PLANNING AND ZONING BOARD STAFF REPORT

466 – 506 NE 5th Avenue

Provide a recommendation to the City Commission regarding the utilization of the Masonry Modern Architectural Style on a proposed four-story mixed-use development within the Central Business District (CBD) at 466-506 NE 5th Avenue, pursuant to Land Development Regulations (LDR) Section 4.4.13(F)(3)(e), **Appropriate Architectural Styles**.

2 NORTH ELEVATION
VP = 1/8"

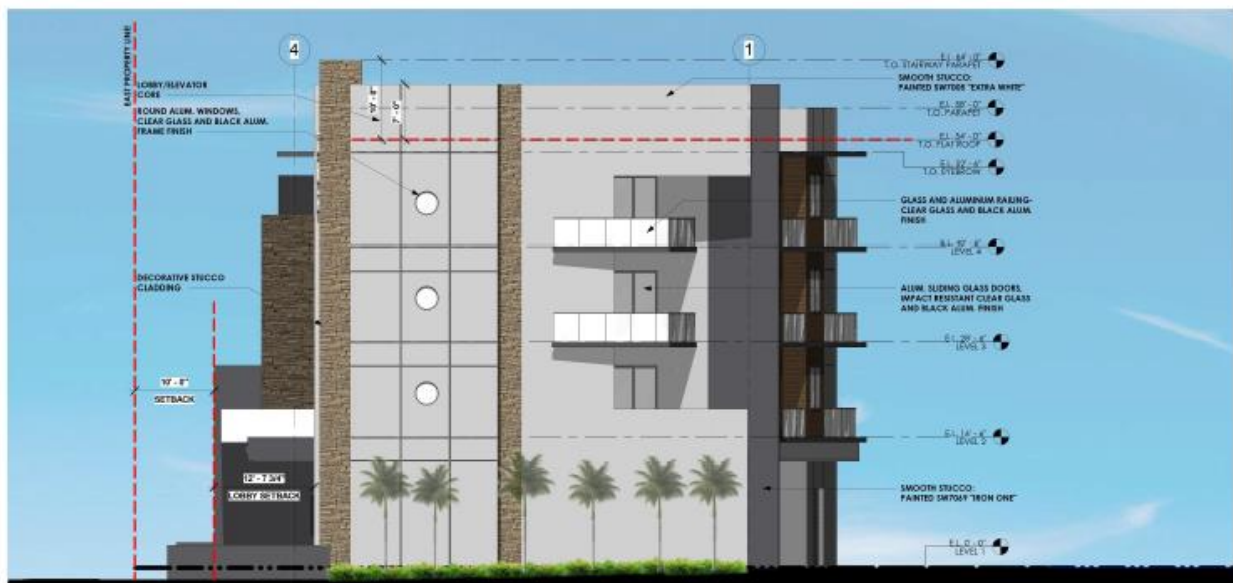
While the submittal references key definitional traits of Masonry Modern such as geometric composition, restrained ornamentation, and masonry expression, the execution presents a surface level application of the style rather than a fully realized interpretation. The elevations rely heavily on flat planes and applied veneers, with limited volumetric carving or climatic responsiveness. This raises questions about whether the design achieves the authenticity, material integrity, and environmental adaptation envisioned by the guidelines.

The building as proposed satisfies the minimum stylistic criteria, but its architectural presence risks being generic rather than distinctive. The lack of strong entry hierarchy, underdeveloped corner treatment, and modest façade relief weaken its contribution to the pedestrian oriented character of the Central Core. A more rigorous application of Masonry Modern principles that emphasizes deeper façade articulation, functional shading devices, and authentic structural expression would be necessary to elevate the design from compliance to true contextual fit.

- Massing and Facade Composition.** The Architectural Guidelines call for buildings in the Central Business District to establish a clear base, middle, and top and to create façades with rhythm and proportion through the use of bays, recesses, and varied planes. In the Masonry Modern style, the building should present itself as a solid form that is carved to create terraces and entries rather than as a flat surface with applied finishes. The east elevation demonstrates some success in meeting these expectations. The ground floor glazing establishes transparency and supports an active street edge, while the stacked balconies above provide a sense of order and rhythm. The proportions are balanced and the direct composition is consistent with the Masonry Modern vocabulary. However, the depth of articulation remains limited. Balconies are modest in projection and windows are only slightly recessed, which reduces opportunities for strong shadow and layered depth that are central to the style. The overall impression is competent but restrained, leaving room for greater emphasis on volumetric carving and pedestrian scale.

On the west elevation, the use of alternating wall planes and balconies shows an effort to avoid visual monotony. This approach is sensible given the long exposure to the railway, yet the composition still reads somewhat flat. A bolder treatment with deeper recesses or more pronounced modulation could strengthen the façade and give it greater presence. The north elevation, oriented toward adjacent parcels, is the least articulated and therefore makes only a minor contribution to the overall streetscape.

At the same time, the reliance on thin stone cladding and painted accent planes raises concerns about authenticity. Masonry Modern emphasizes structural clarity and the sense of mass carved from solid form, yet here the stone treatment reads as a surface application rather than an integral element of construction. The limited depth of balconies and window recesses further reduces the opportunity for shadow and texture, which are essential to the expression of masonry mass. The glazing system provides transparency at the ground level and supports the pedestrian orientation of NE 5th Avenue. Above the base, however,

the window design is simple and repetitive. While this approach creates order, it also risks appearing generic and does not take full advantage of the style's potential for variation in masonry openings. Additional refinement, such as deeper window recesses, more pronounced frames, or subtle modulation in balcony design, could enhance both authenticity and visual richness.

- **Roofline and Corner Treatment.** The building employs a flat roof concealed by a parapet, which is consistent with the Masonry Modern style. The horizontal line of the parapet provides a clean profile, but it remains uniform and lacks variation. The guidelines encourage the upper portions of buildings to create visual relief through terraces, deep overhangs, or sculptural elements that provide both shade and identity. In this proposal, the roofline is restrained and does not introduce features that could enrich the composition or improve climatic response.

Because the project is located mid-block, the so-called corner element does not function as an urban marker at a street intersection. Instead, it serves as a vertical accent within a continuous frontage. While the attempt to introduce variation is noted, the treatment is modest and does not create a strong hierarchy within the overall massing. In this context, greater benefit could be achieved through enhanced articulation of the mid-block façade, stronger definition of the main entry sequence, or more expressive vertical breaks that provide rhythm between adjoining properties.

Despite these strengths, the ground floor lacks a clearly identifiable main entrance. The entry is designed as part of the storefront system and is therefore visually understated. In the context of the Central Core Sub-district, where guidelines call for entries to be prominent and legible, the absence of a distinctive threshold weakens the building's presence on NE 5th Avenue. A stronger gesture through a canopy, taller glazing, or differentiated framing would create a hierarchy that signals arrival and reinforces the base of the building. The civic open space proposed along the southern frontage demonstrates thoughtful design by including raised planters, benches, a water feature, and a pet-friendly fountain. These elements create an amenity for both residents and the public, and they exceed the minimum open space requirement. However, the placement of this space away from the primary entrance reduces its ability to reinforce the identity of the building. If the civic space were better connected to the entry sequence, it could act as a forecourt that announces the building and strengthens its urban presence.
